**LONG FORM INFORMATION RESPONSE
AREA 1**

FILE 5874

13 April 2011

RE: IR RESPONSE – DEV2010/084 – RIPLEY VALLEY AREA 1

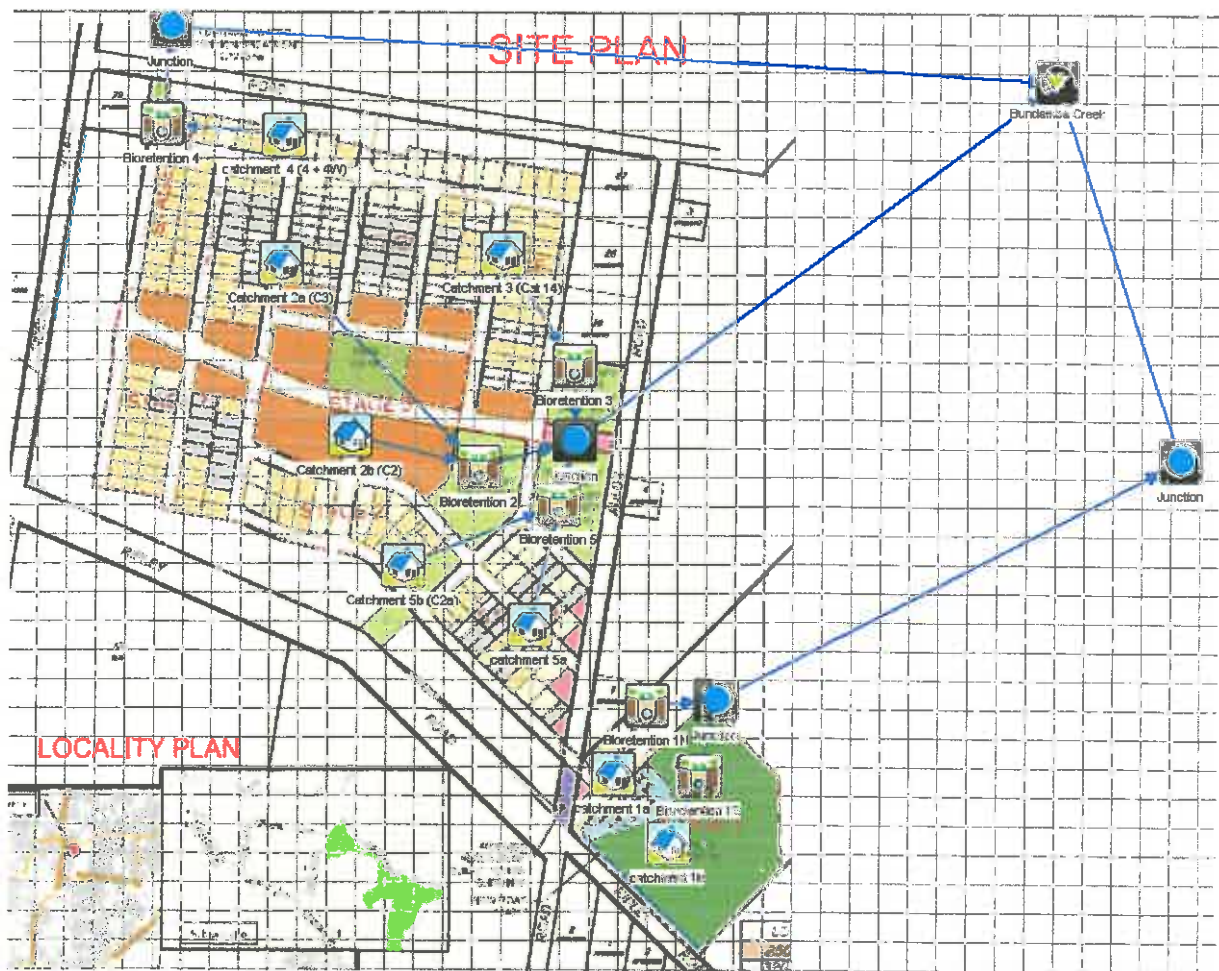
S11 Show how the MUSIC Model for the site should include parklands and demonstrate that the Water Quality Objective (WQO) is achieved at the site outlet.

Refer to MPNs’ SMP section 7.5 (see Appendix I of the main report by Land Partners) and below modified Figure 7-1 that the Neighbourhood Park has been incorporated into the MUSIC model as a node and that the proposed treatment train achieves the pollution and nutrient removal targets set by Healthy Waterways.

ATTACHMENT 1
MPN Drawing 5874-PSK70

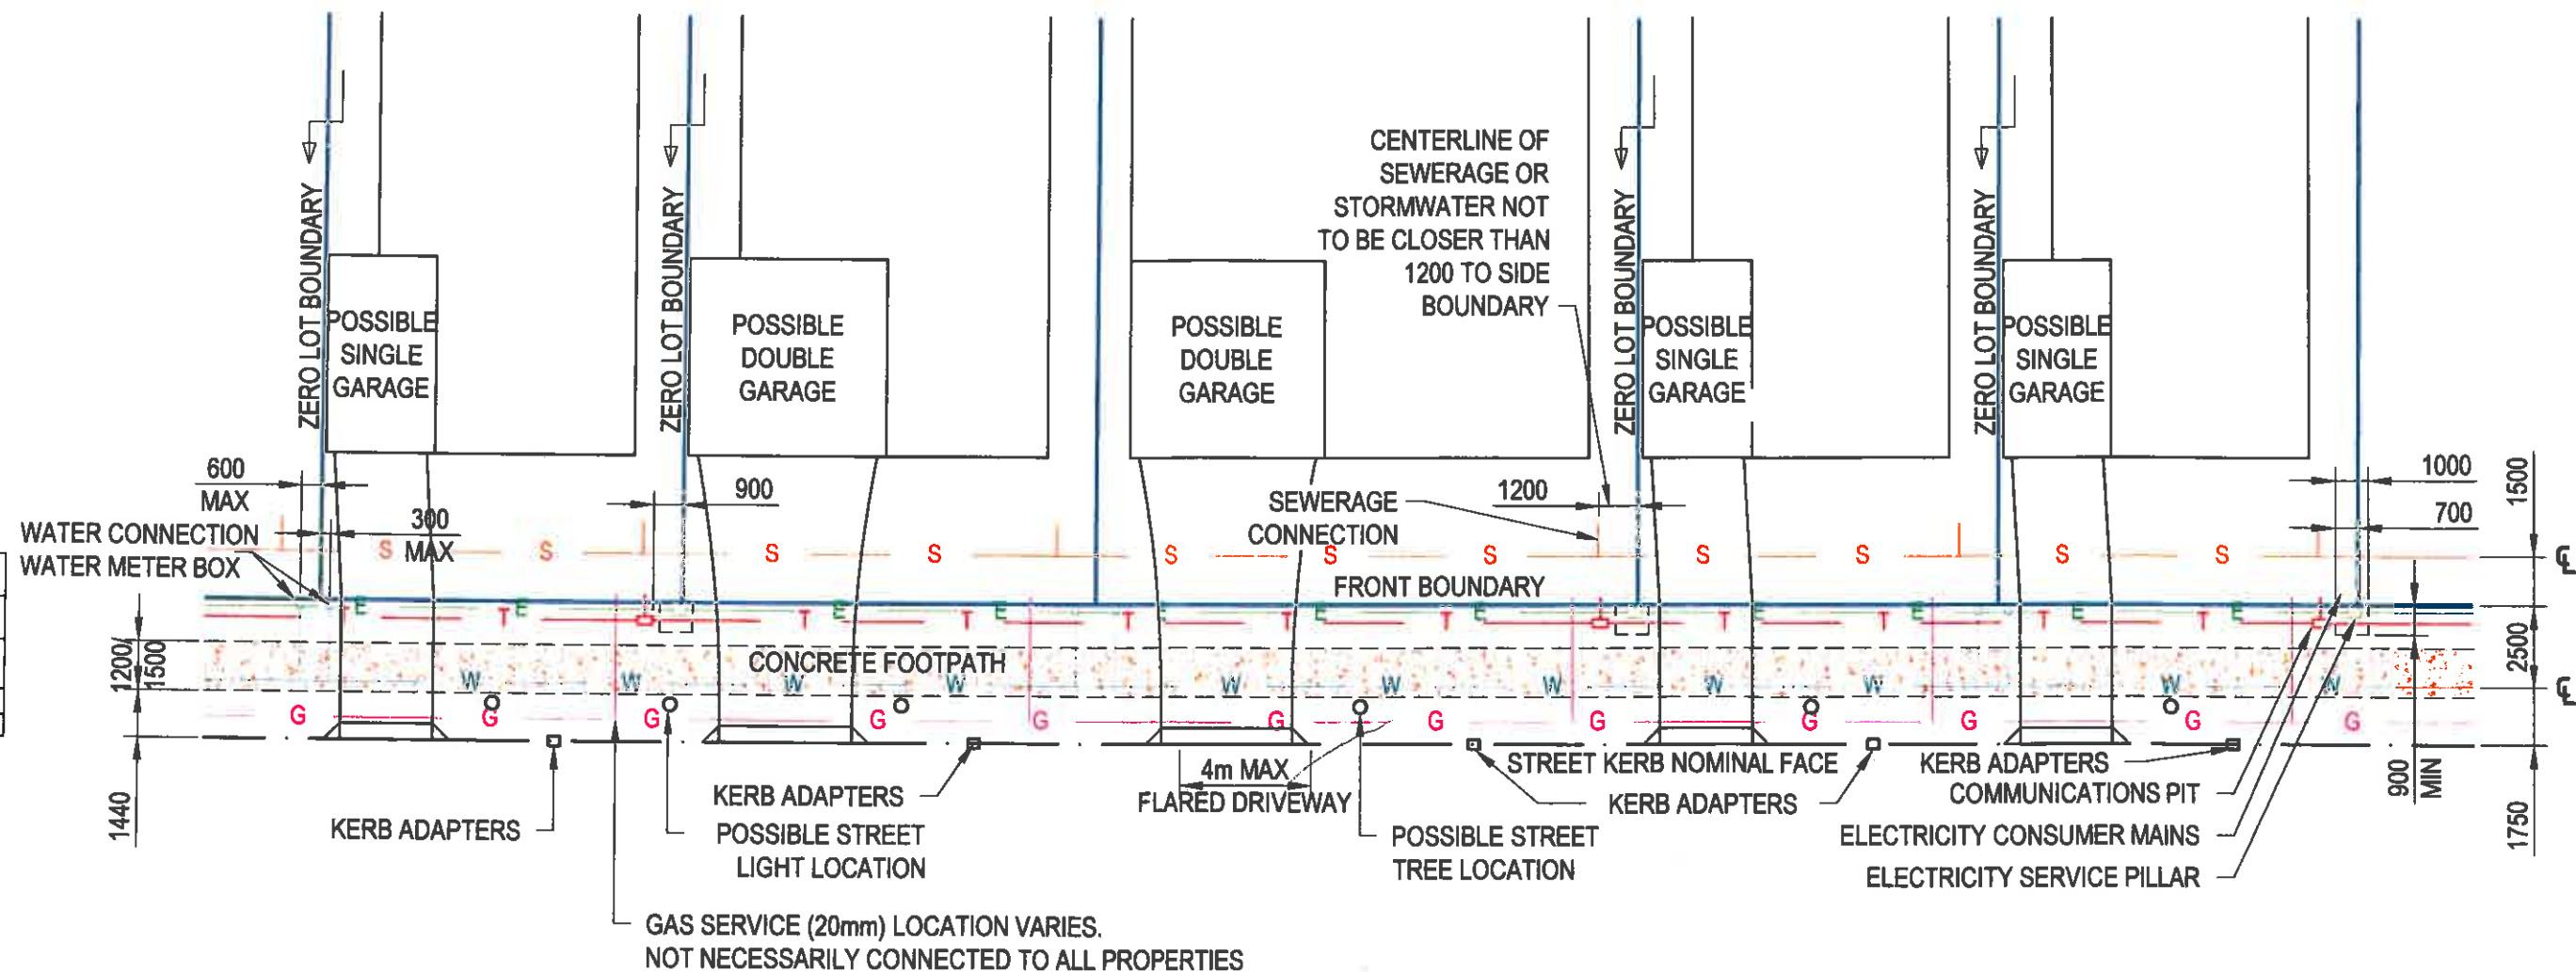
E2 Services Plan showing the location of services within the road reserves for areas with zero boundary setbacks.

Refer to the attached MPN Drawing No 5874 - PSK70 (Attachment 1) which indicates the locations of Stormwater, Roofwater, Sewerage Reticulation, Water Supply, Gas, Concrete Footpaths etc in the vicinity of zero boundary setbacks.

ATTACHMENT 8
MPN Drawing 5874-PSK80

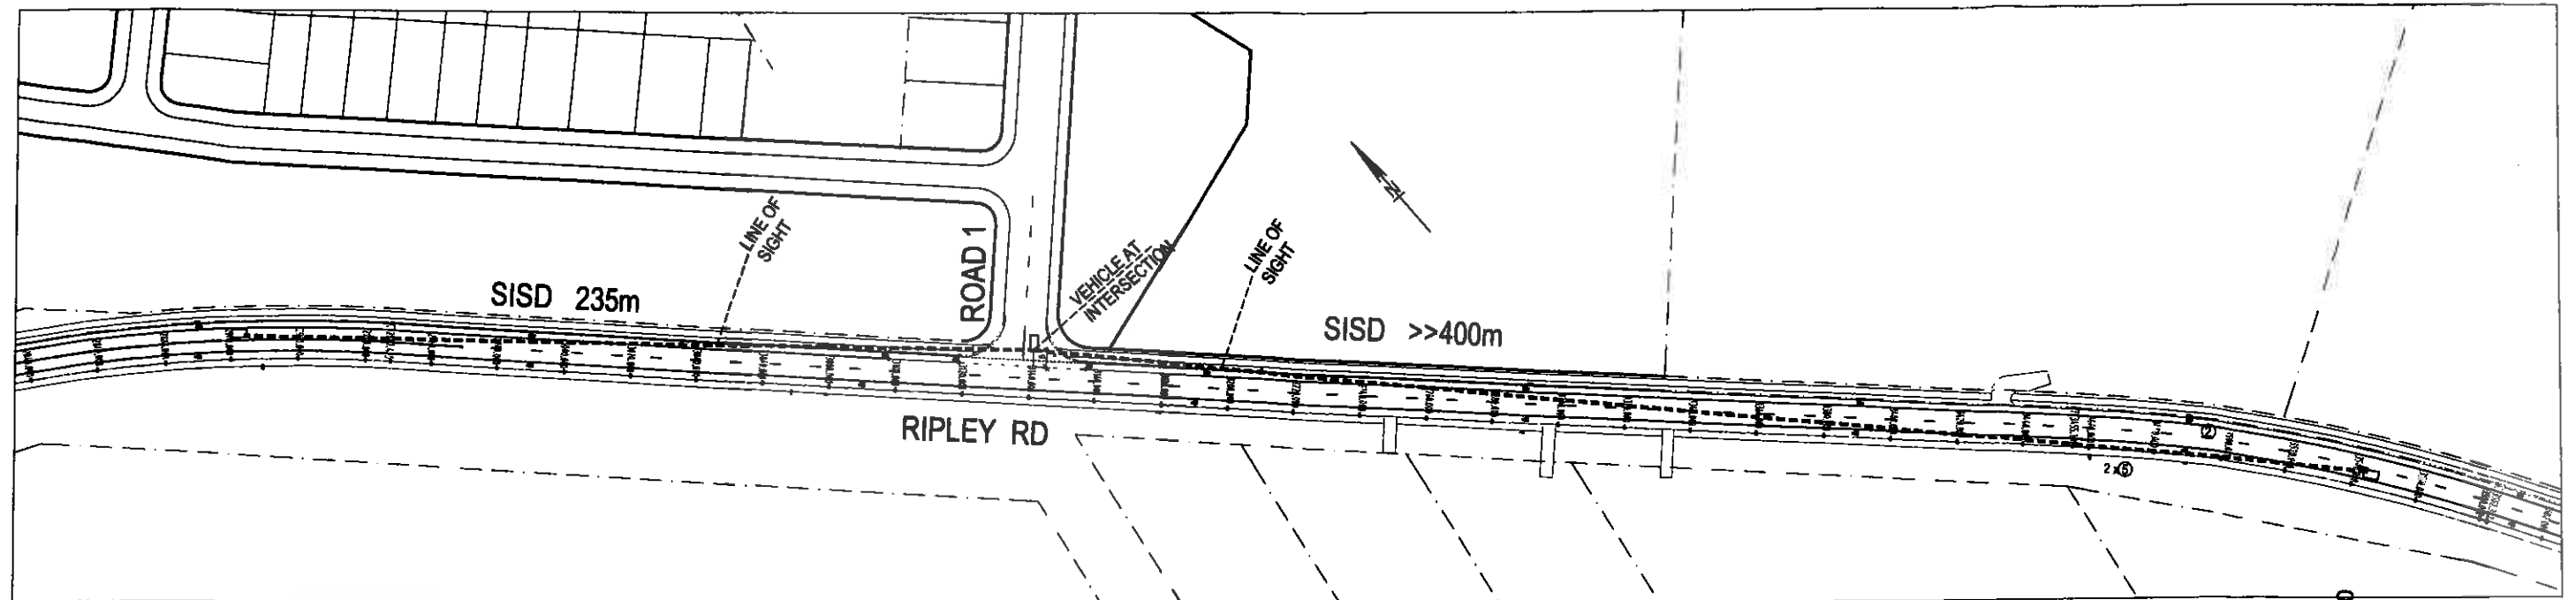
G12 Prepare an Erosion and Sediment Control Plan that considers the relevant aspects of soil type, hydrology, the types of erosion and sediment control devices required on the site and the space opportunities for these, and link the soil treatment to the proposed landscape outcomes. It should be noted that the highly dispersive nature of the clay component of the soils, combined with the unstable sands make the site HIGH RISK from an erosion perspective.

Refer to attached MPNs' Drawing No 5874 - PSK80 (Attachment 8) for the locations of Temporary Sediment Basins. The notes on this plan incorporate the ESSA treatments of topsoils and dispersive subsoils and the process associated with flocculation, discharge of clean water and the cleaning out of settled sediment. The Erosion and Sediment Control Plan utilises the temporary Bioretention Basin and Attenuation areas adjacent to Auld's Road during the earthworks disturbance phases of stages 1, 2 and 8 prior to being completed to perform their Bioretention role in the permanent treatment train for Area 1. Upstream stages 4 to 7 & 9 will require their own Temporary Sediment Basins which will revert to allotments once there is sufficient grass strike to disturbed areas.

ATTACHMENT 9
MPN Drawing 5784-PSK82

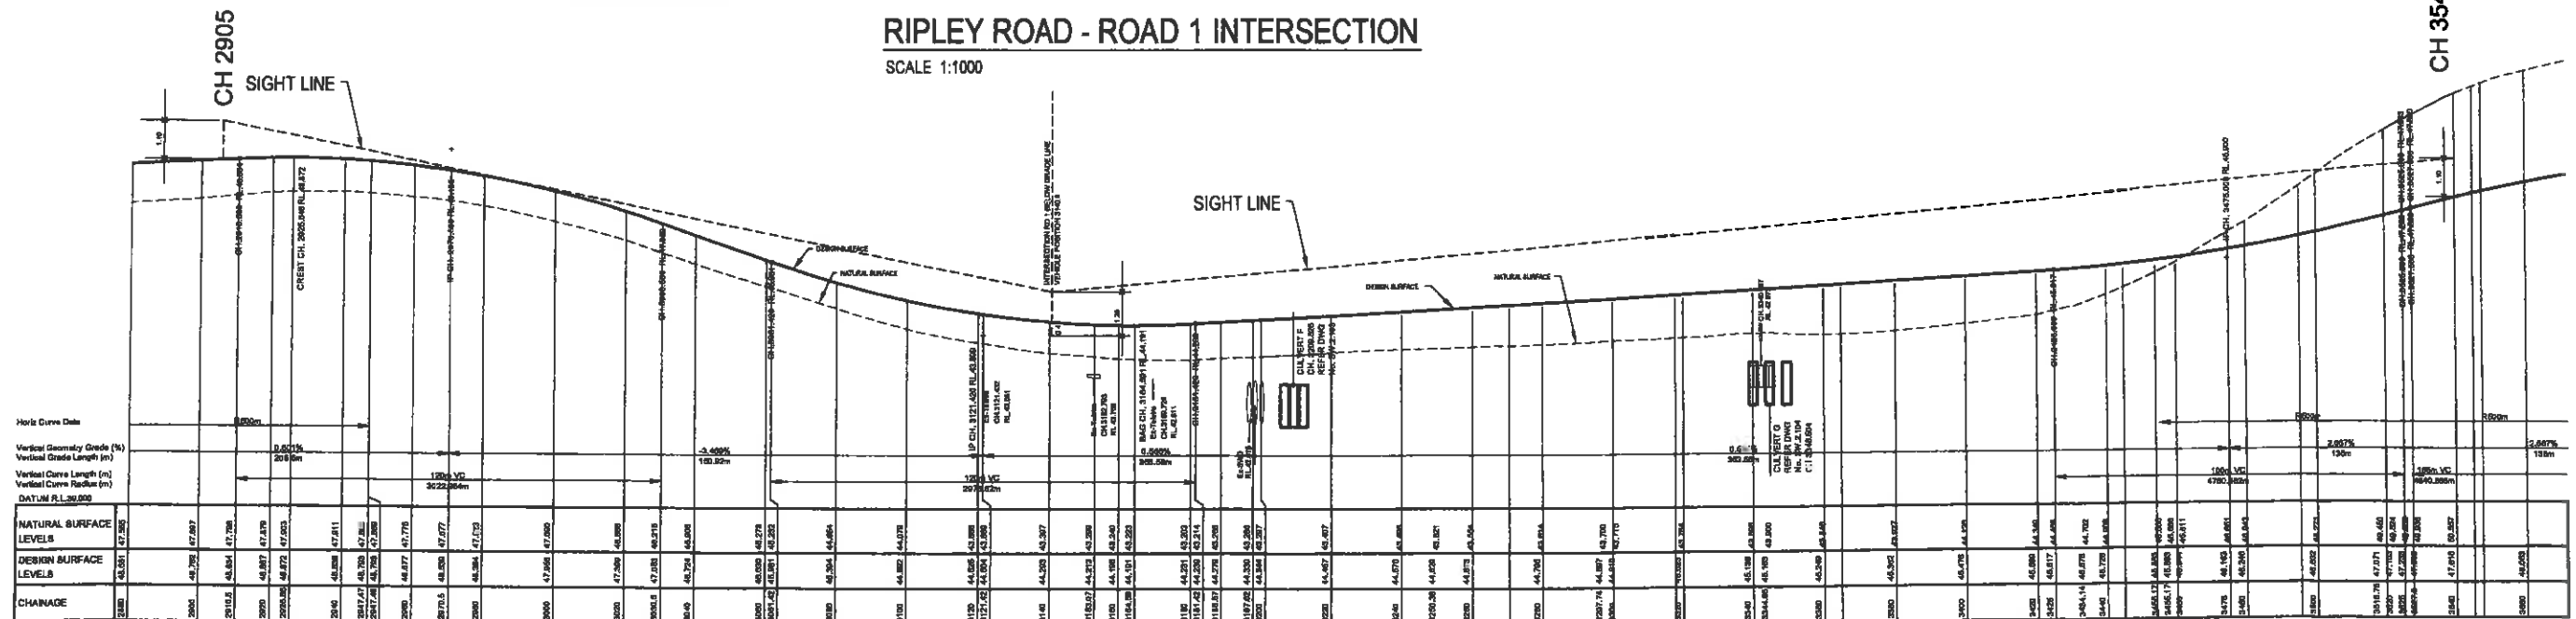
T12 Perform sight distance assessment at the proposed access points in Fischer road and Ripley Road and provide recommendations on mitigation measures (if required).

- i. Refer to Landpartners revised POD, access from Fischer Road is not proposed for Area 1.
- ii. Refer to attached MPNs' Drawing No 5874 - PSK82 (Attachment 9) which details the layout of the Ripley and Aulds Road's intersection. The site lines demonstrate compliance of this intersection to Austroads Design Guidelines.

ANNEXURE C
MPN Drawing Number 5874-PSK42 and 5874-PSK93

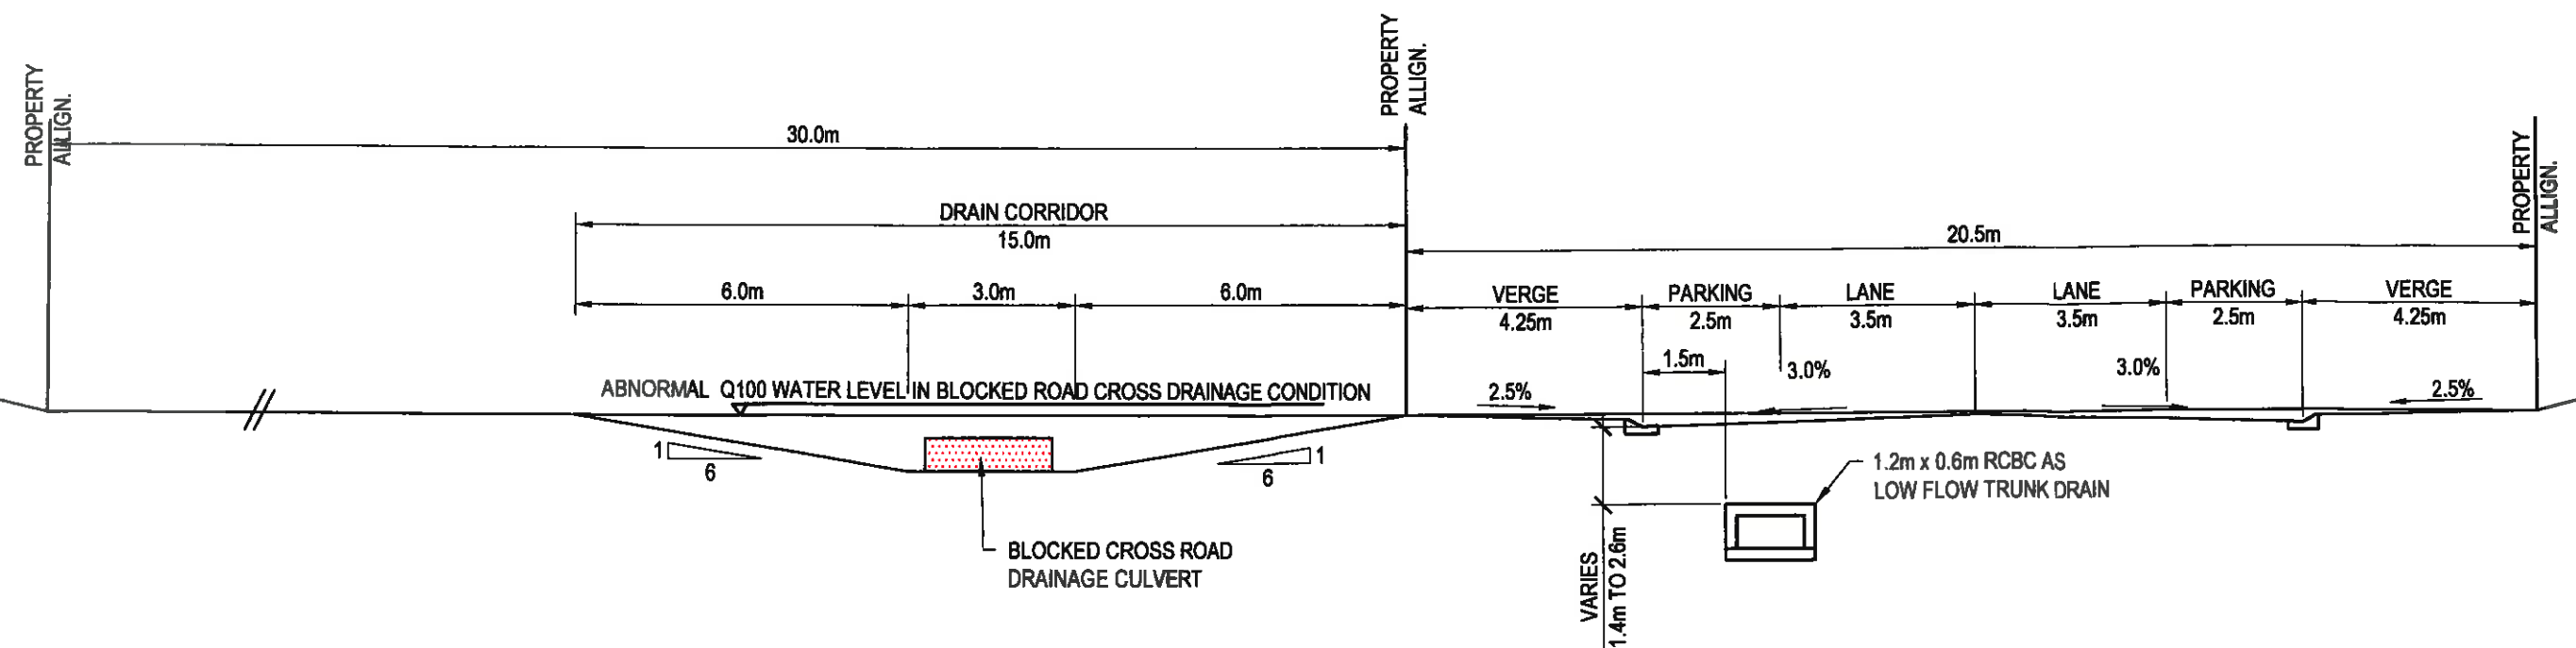
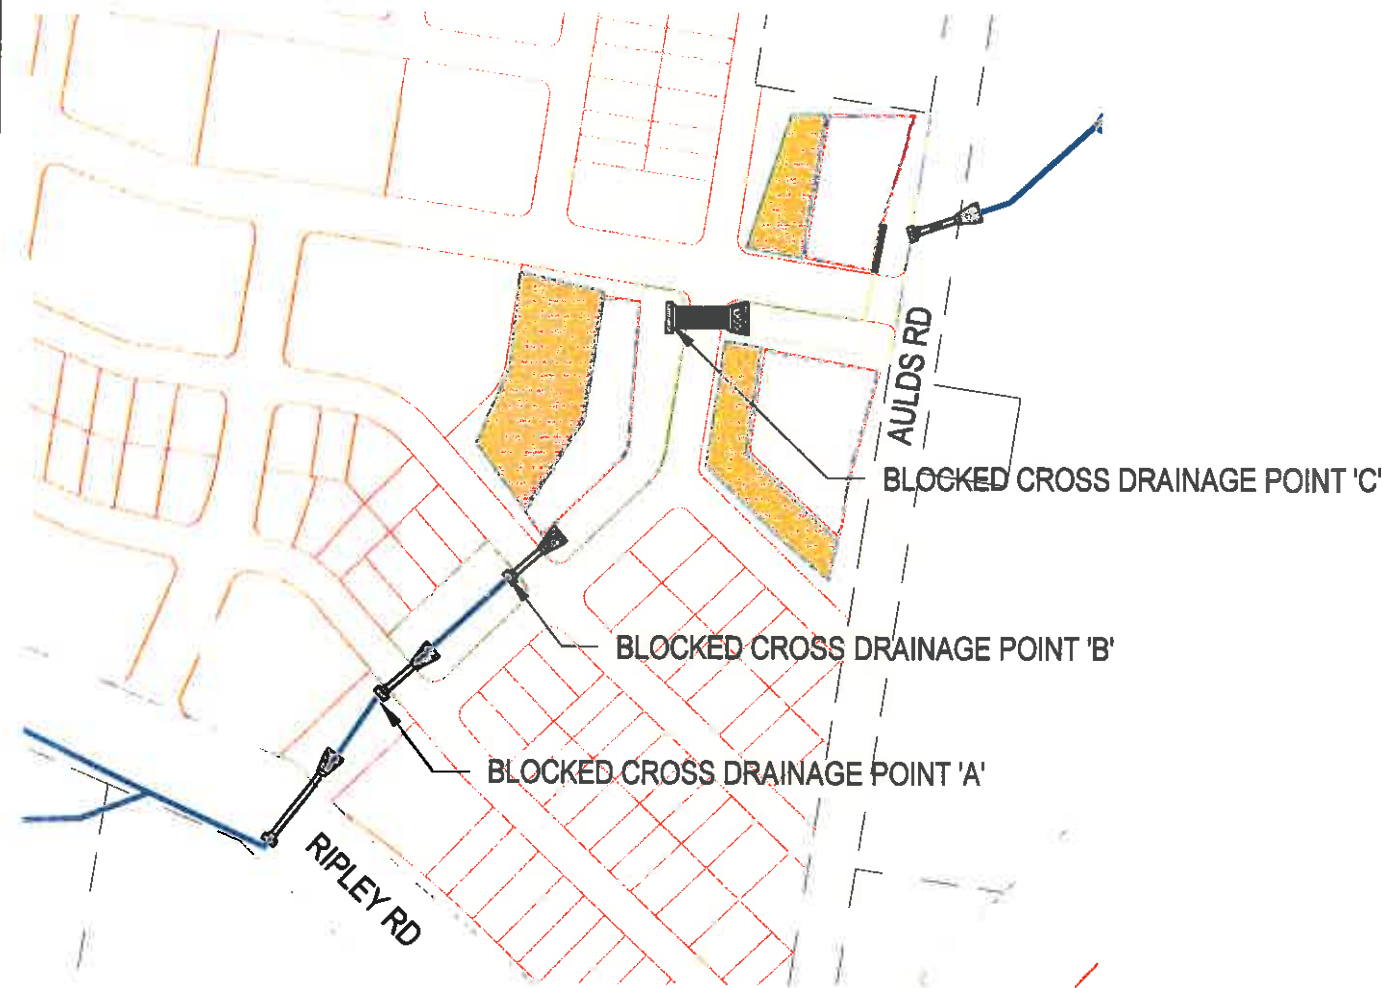
S3 Provide evidence of adequate stormwater drainage to accommodate the Q100 flows to avoid overland flows through Lots 305-311, 316-322, 465 and the future attached housing lots.

Refer to the revised POD, MPNs' SMP section 5.2 (see Appendix I of the main report by Land Partners), HIR response in Appendix A of this report (separate booklet) (Drawing No 5874 – RP03 and PSK 42) which demonstrates the conveyance of Q100 flows through Area 1 complying with velocity depth product and freeboard requirements of QUDM.
